RE: Revised Application Deficiency Report #4 - Certificate of Public Convenience and Necessity for the Riverside Transmission Reliability Project – Application No. A.15-04-013

DEFICIENCY REPORT #4 (REVISED) FOR THE RIVERSIDE TRANSMISSION RELIABILITY PROJECT APPLICATION (A. 15-04-013)

Table 1: SCE Riverside Transmission Reliability Project Application 15-04-013 Deficiency Report #4 (Revised 09/22/2016)

-  ROW
-  Tube Structure
-  Proposed Transmission Line
-  Indicative Access Road
-  GDAD Buffer Area
-  Land and Water Conservation Fund
-  Freshwater Emergent Wetland
-  Freshwater Forested/Shrub Wetland
-  Freshwater Pond
-  Riverine

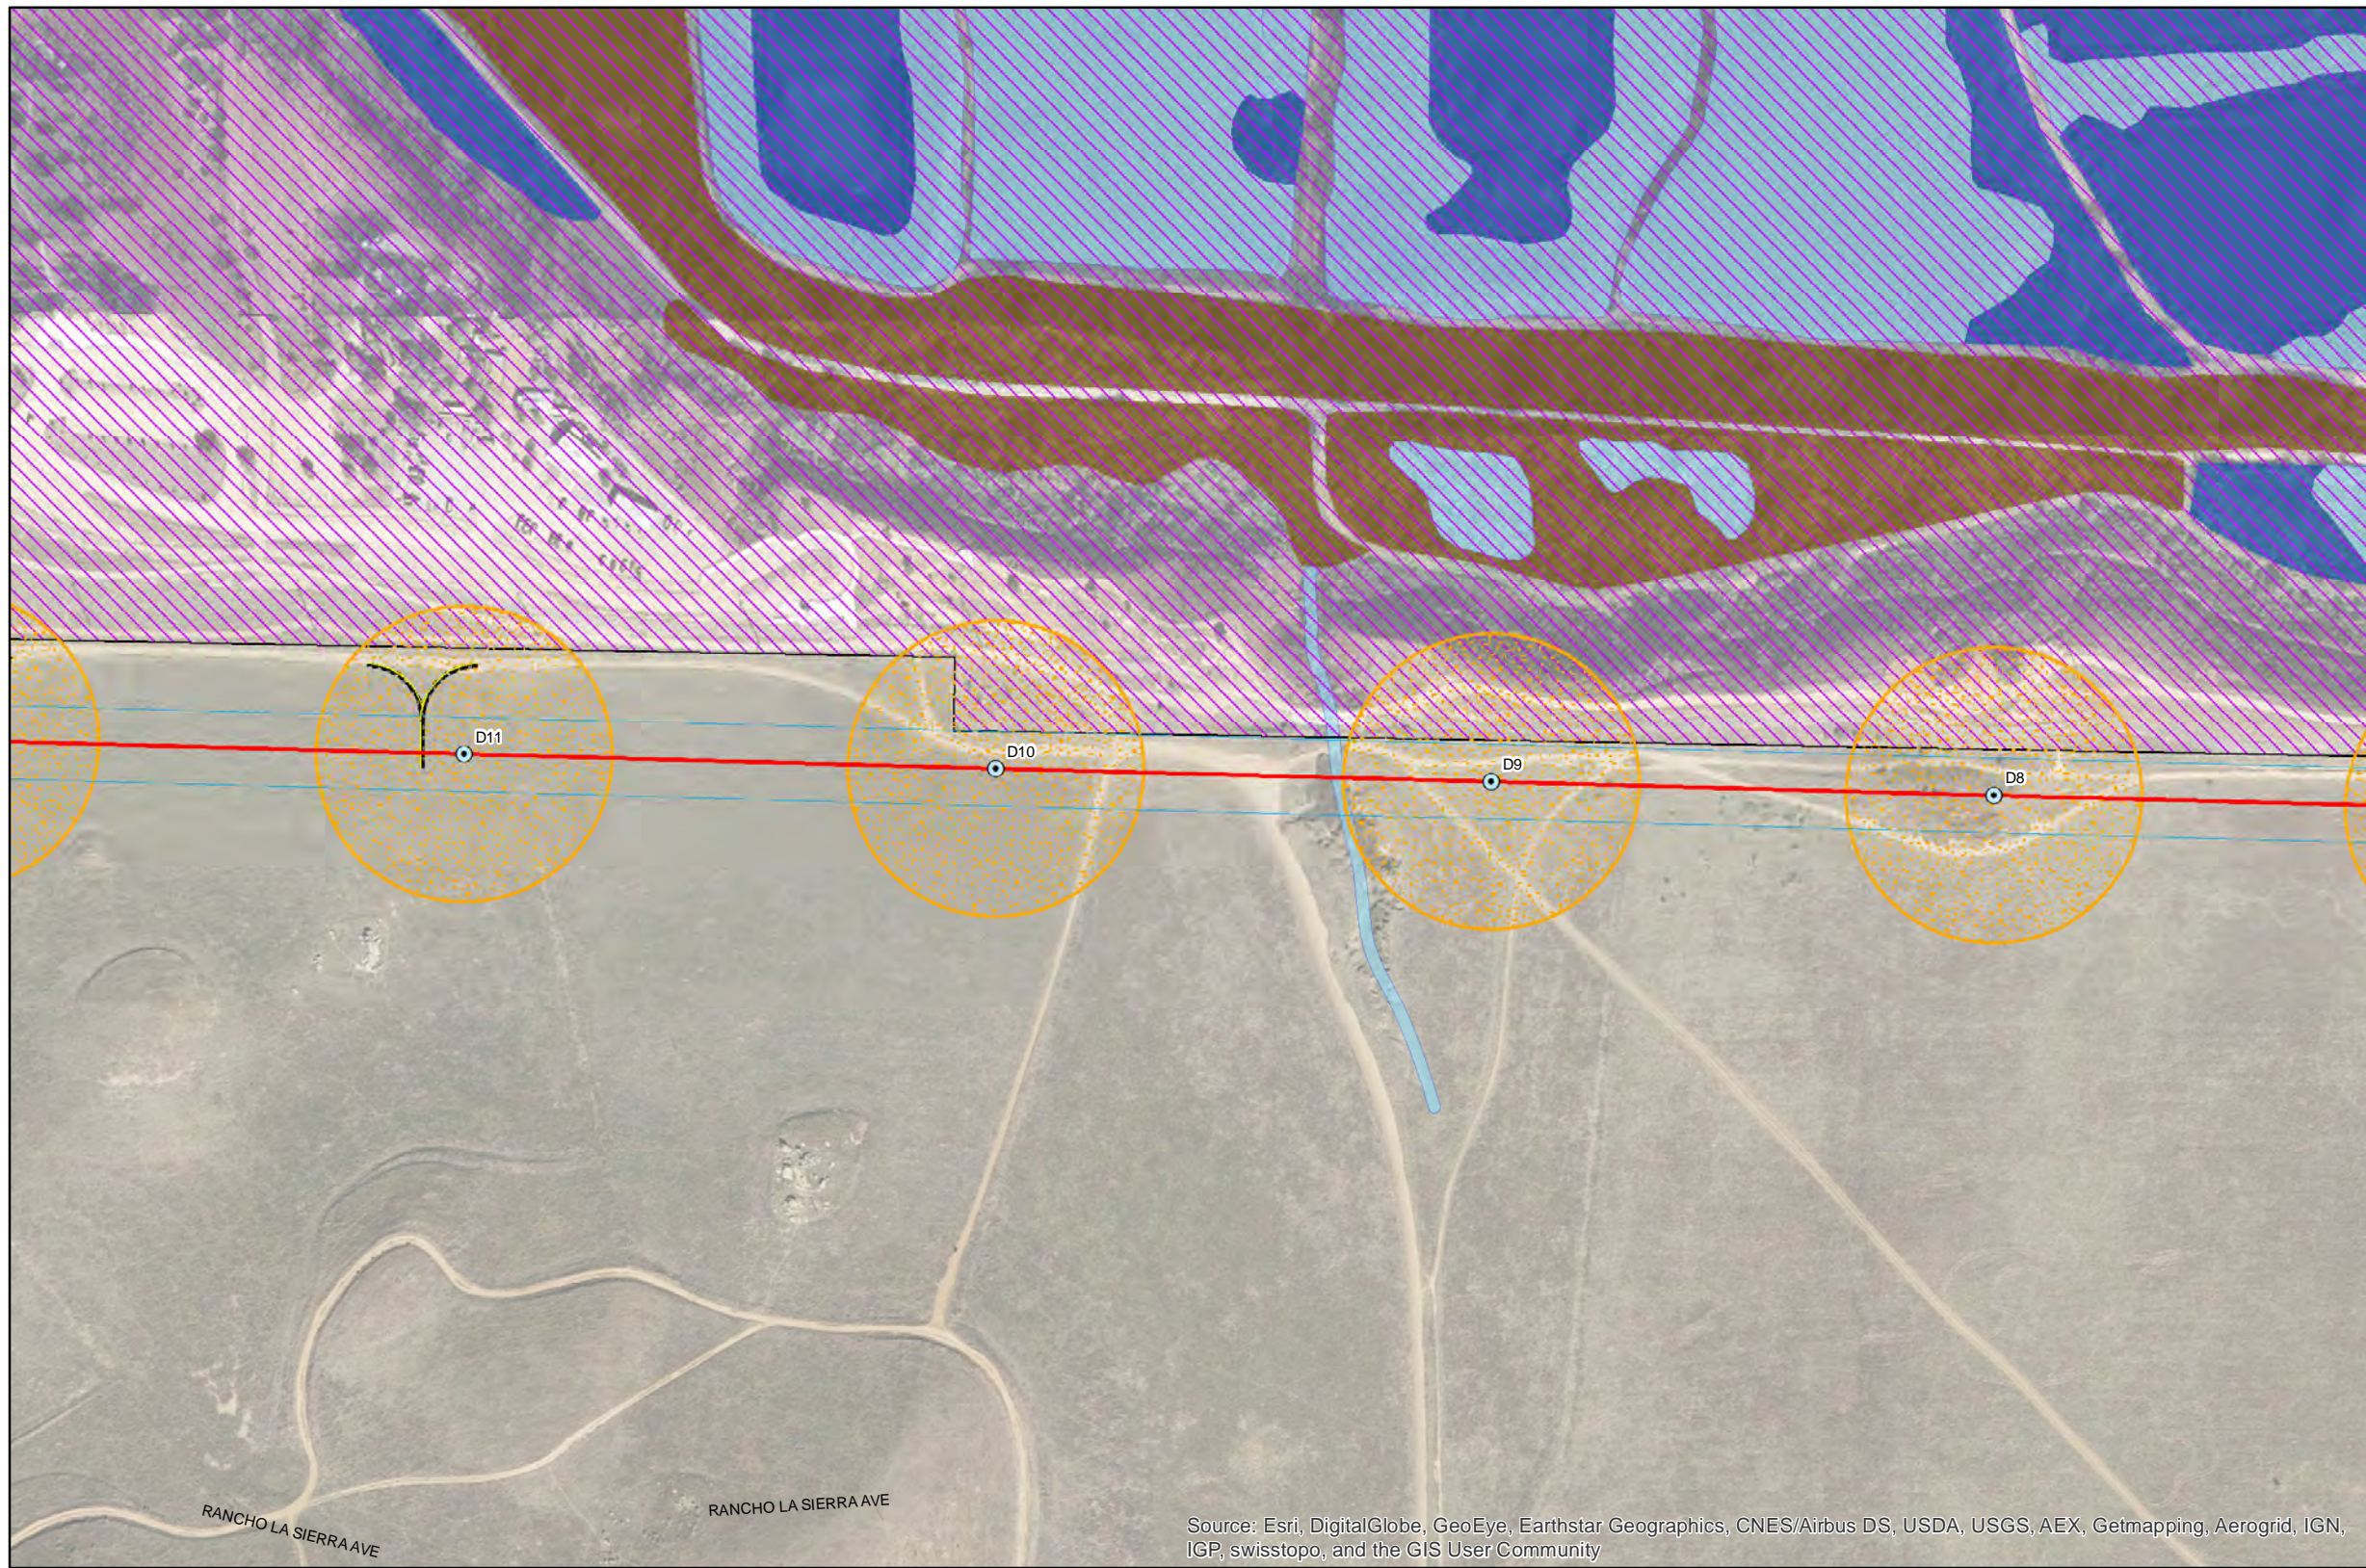
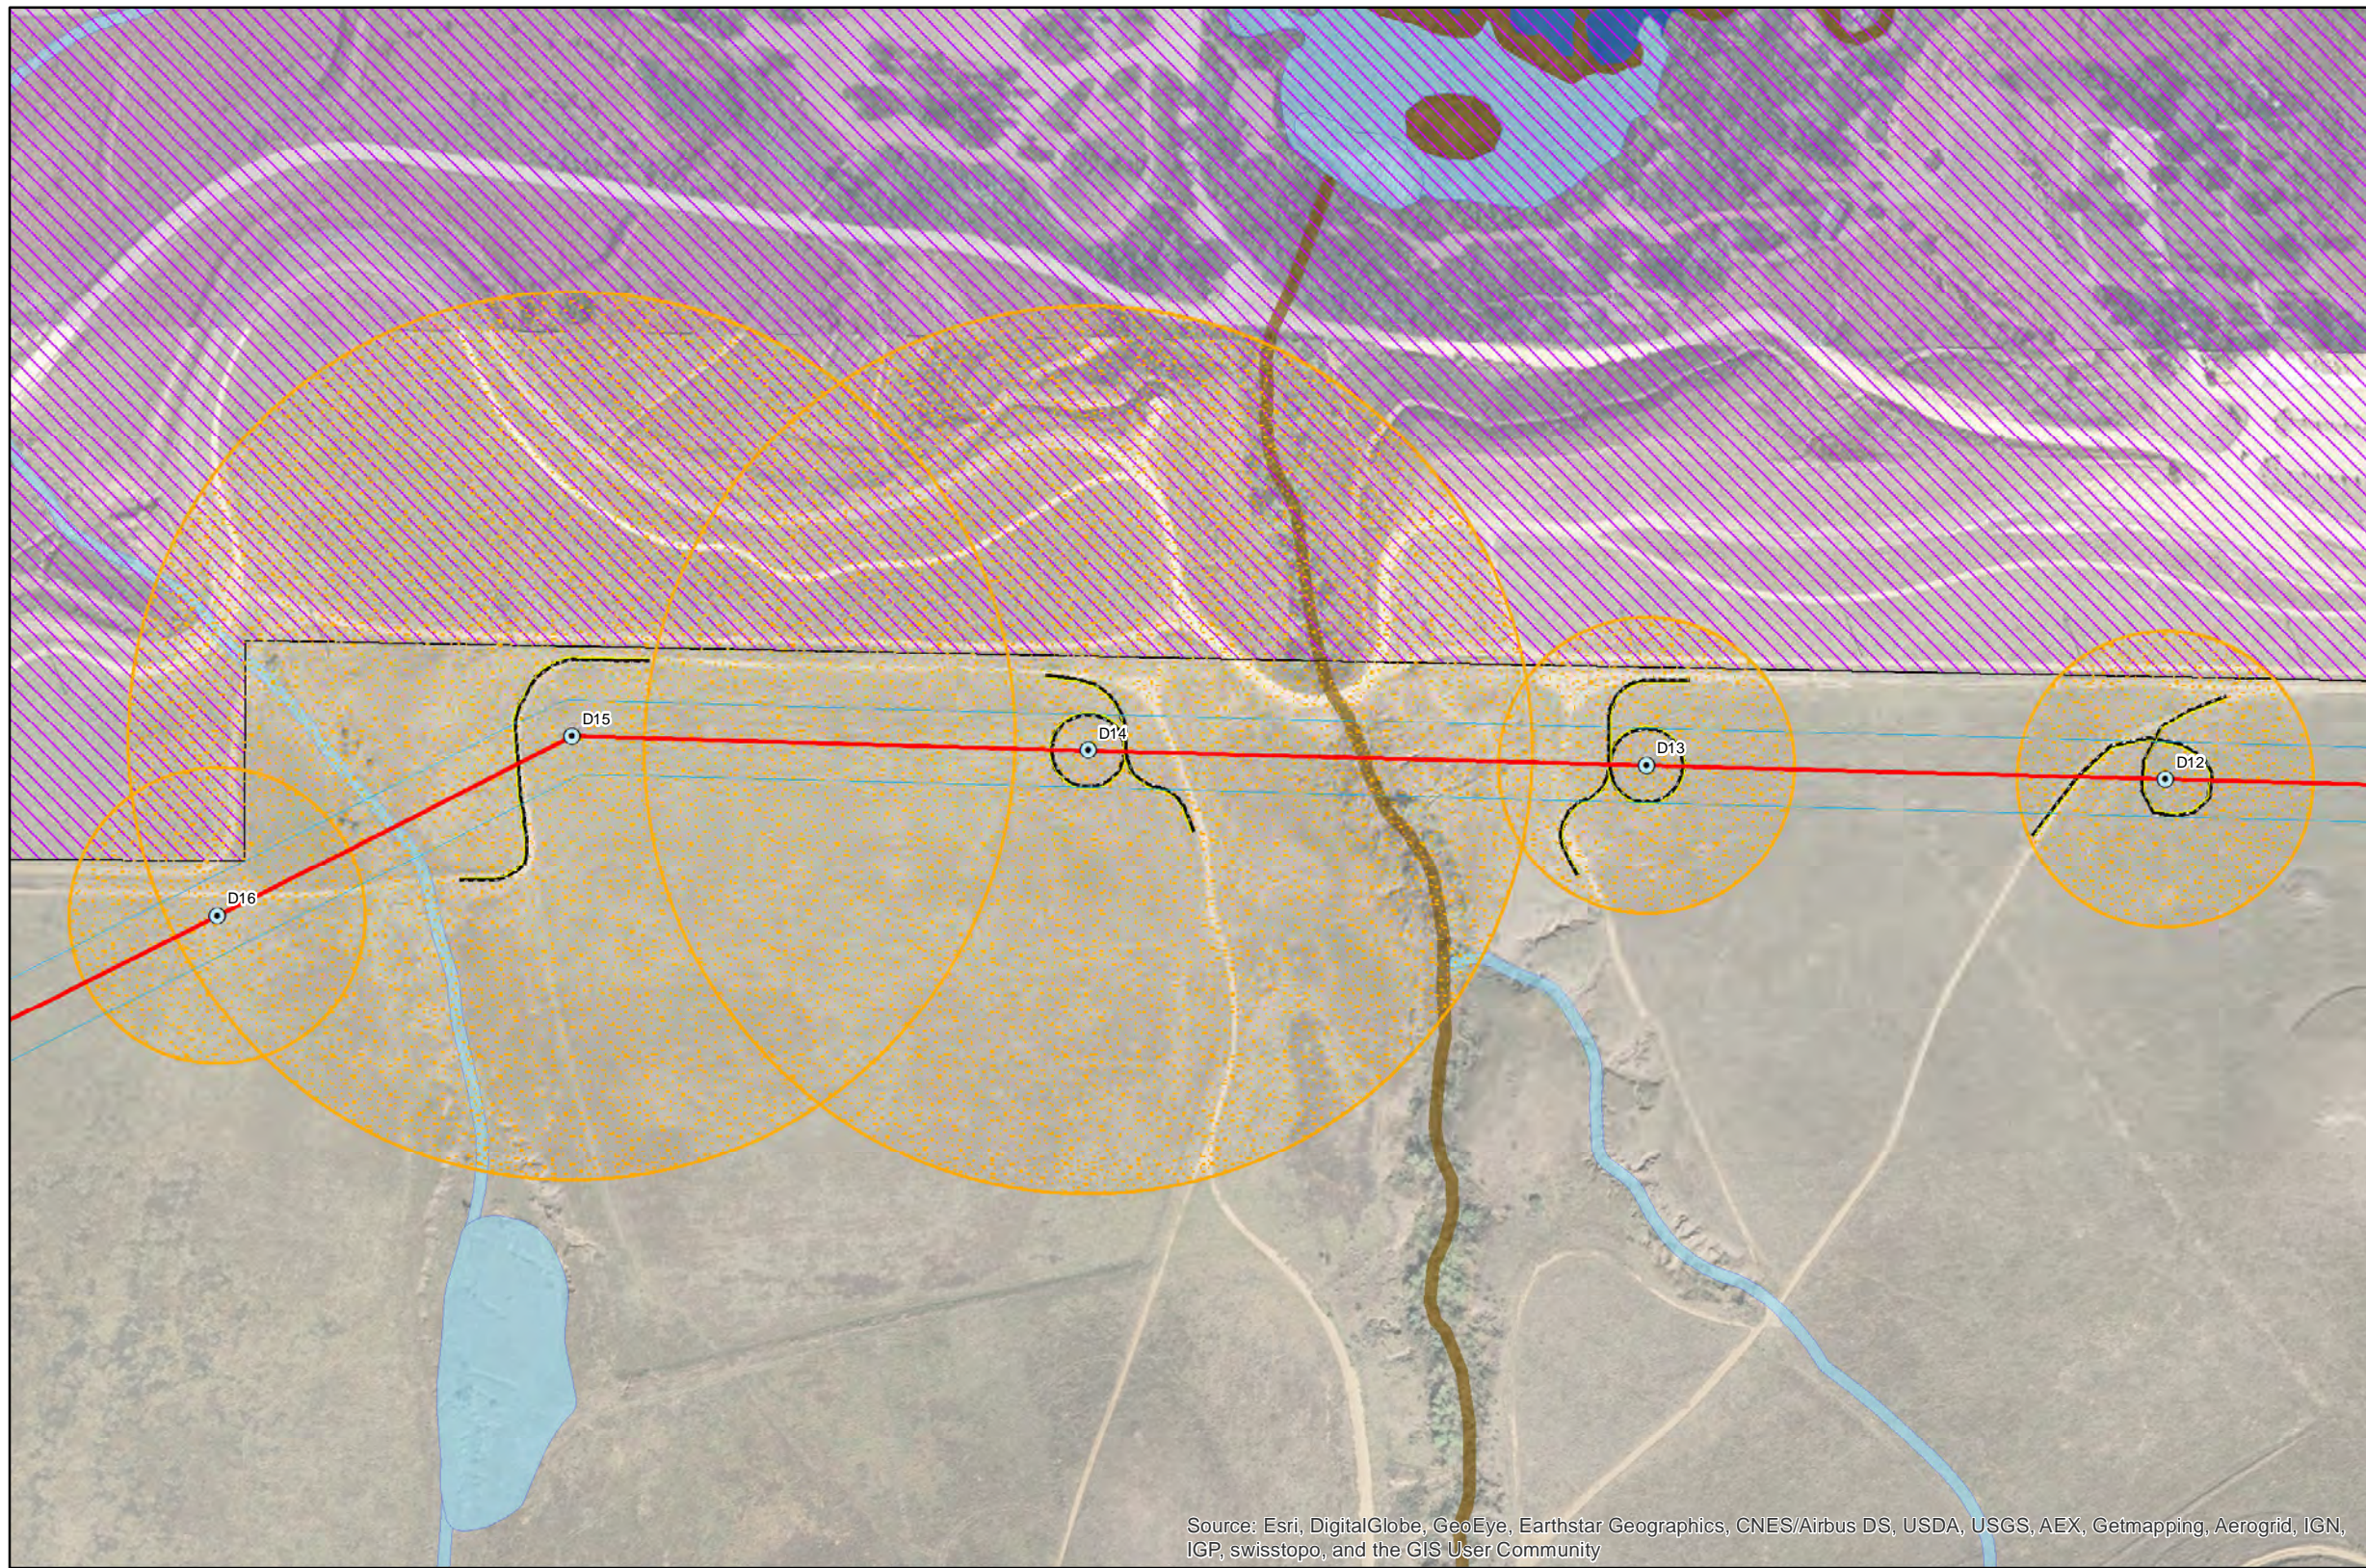
Number	Information Requested Previously?	Deficiency
		<p>The CPUC has prepared a mapbook (Attachment A) showing locations where the proposed buffer areas overlap with the following facilities and resources within the overhead alignment southeast of the Santa Ana River:</p> <ul style="list-style-type: none"> • Steep slopes • Wetlands including the Santa Ana River floodplain and/or tributary drainages • Metropolitan Water District's aqueduct infrastructure • City streets, parking lots, loading/receiving docks, and perimeter landscaping of adjacent buildings • Riverside Water Quality Control Plant facilities • Hidden Valley Wilderness Area (federal land and water conservation fund area) <p>These resources should be avoided and carved out of the work area buffers, where feasible.</p> <p>The revised preliminary engineering plans and detailed route maps should also depict alignment revisions including the proposed underground alignment along Pats Ranch Road and 68th Street, and revised overhead alignment north of Limonite Avenue.</p> <p>Please include GIS data files for all detailed route map refinements.</p>
